The Commission has issued the enclosed Amendment No. 104 to Facility Operating License No. DPR-31 and Amendment No. 98 to Facility Operating License No. DPR-41 for the Turkey Point Plant Units Nos. 3 and 4, respectively. The amendments consist of changes to the Technical Specifications in response to your application transmitted by letter dated August 6, 1982, as modified on September 1, 1982, January 3, 1983, April 25, 1983, January 31, 1984 and April 23, 1984.

SAFETY EVALUATION BY THE OFFICE OF NUCLEAR REACTOR REGULATION
RELATED TO AMENDMENT NO.104 TO FACILITY OPERATING LICENSE NO. DPR-31
AND AMENDMENT NO. 98 TO FACILITY OPERATING LICENSE NO. DPR-41
FLORIDA POWER AND LIGHT COMPANY
TURKEY POINT PLANT, UNIT NOS. 3 AND 4
DOCKET NOS. 50-250 AND 50-251

TECHNICAL EVALUATION REPORT (REVISION 1)
ON THE PROPOSED DESIGN MODIFICATIONS AND
TECHNICAL SPECIFICATION CHANGES ON
GRID VOLTAGE DEGRADATION FOR THE
TURKEY POINT NUCLEAR GENERATING PLANT
UNITS 3 AND 4

FIGURE 1 TURKEY POINT UNITS 3 AND 4 ELECTRICAL ONE-LINE DIAGRAM

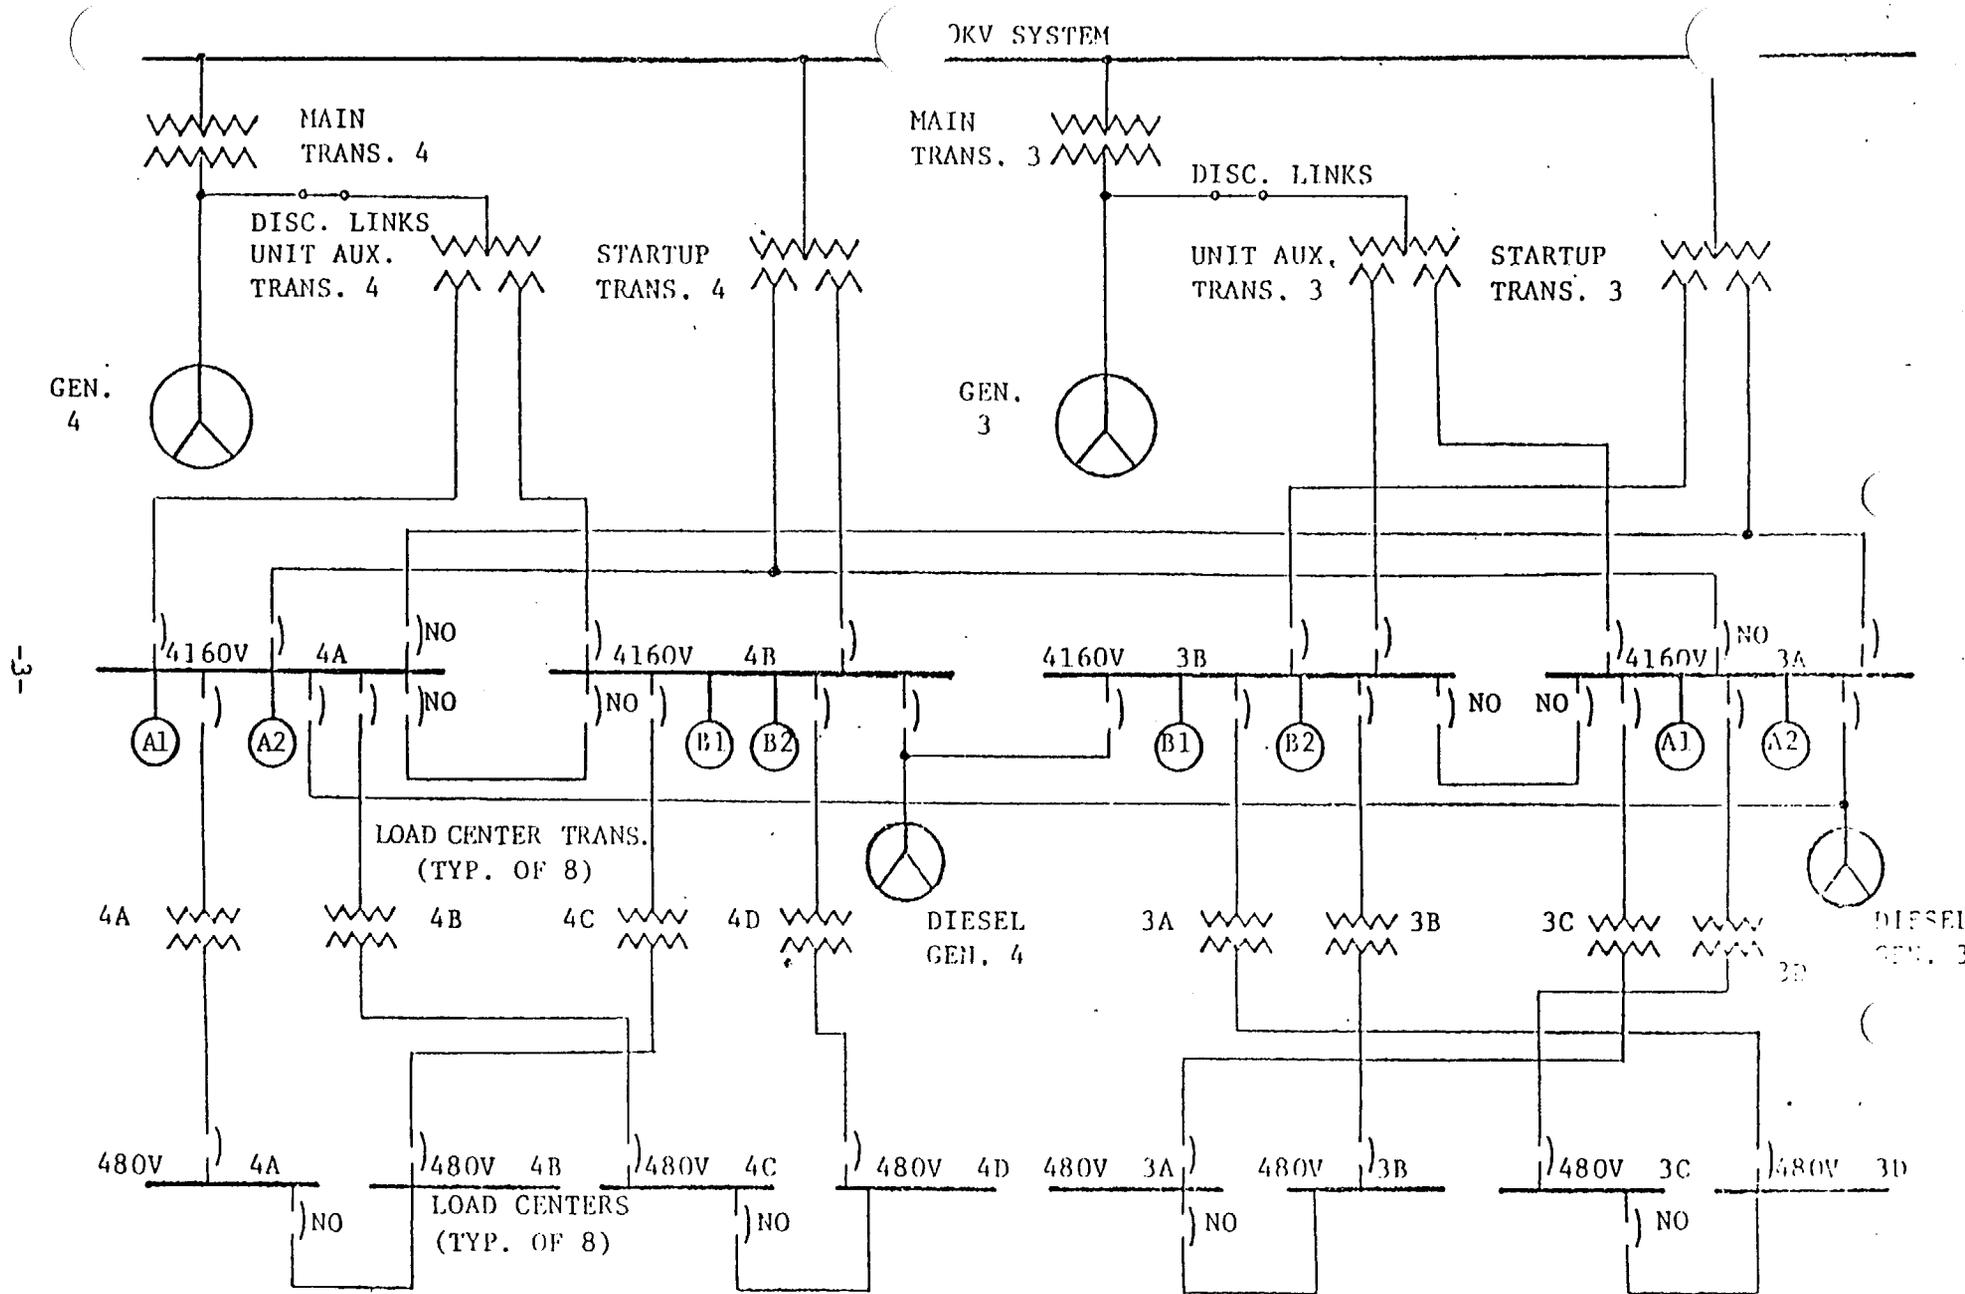
The present undervoltage protection design utilizes two undervoltage relays on each of the 4160-volt Class 1E buses (Buses A and B of Figure 1). The relays are instantaneous type HGA which respond at 40% - 50% of 4160 volts. These relays are used as loss-of-voltage protection.

The relay logic (2-out-of-2) is such that actuation of one relay (A1 or A2) on "A" bus in conjunction with the actuation of its interconnected relay (B1 or B2) on "B" bus will initiate the offsite source disconnection, load shedding, diesel generator starting and subsequent load sequencing on both buses. For example, the starting of diesel generator 3 and the disconnection of startup transformer 3 is initiated by the actuation of relay A1 on bus 3A and relay B2 on bus 3B or the actuation of relay A1 and the starting sequence of diesel generator 4. This logic scheme results in two separate and redundant circuits.

- (1) The logic of the existing relays will be reconnected such that the offsite source disconnection, load shedding, diesel generator starting, and load sequencing will occur only for that bus on which the loss of voltage occurs. The logic will remain 2-out-of-2 but the scheme on bus A will now be independent of that on bus B.

- (2) The installation of two additional instantaneous relays (type ITE27H) with a definite-time delay and two inverse-time relays (type IAV) with a definite-time delay on each 480-volt Class 1E load center. Both sets of relays will be in a 2-out-of-2 coincident logic scheme. The instantaneous relays will protect the Class 1E equipment at both the 4 kV and 480-volt levels from sustained degraded voltages under accident conditions. The inverse-time relays will also protect the Class 1E equipment at both voltage levels under non-accident conditions. Actuation of either set of relays will initiate the tripping of the incoming 4 kV feeder breakers, diesel generator starting, load shedding, and subsequent load sequencing. Both sets of the relays (instantaneous and inverse time) are also interlocked with the 'b' contact of diesel generator breaker to disable the load-shedding feature when the diesel generators are on line and to reinstate the feature following breaker tripping.
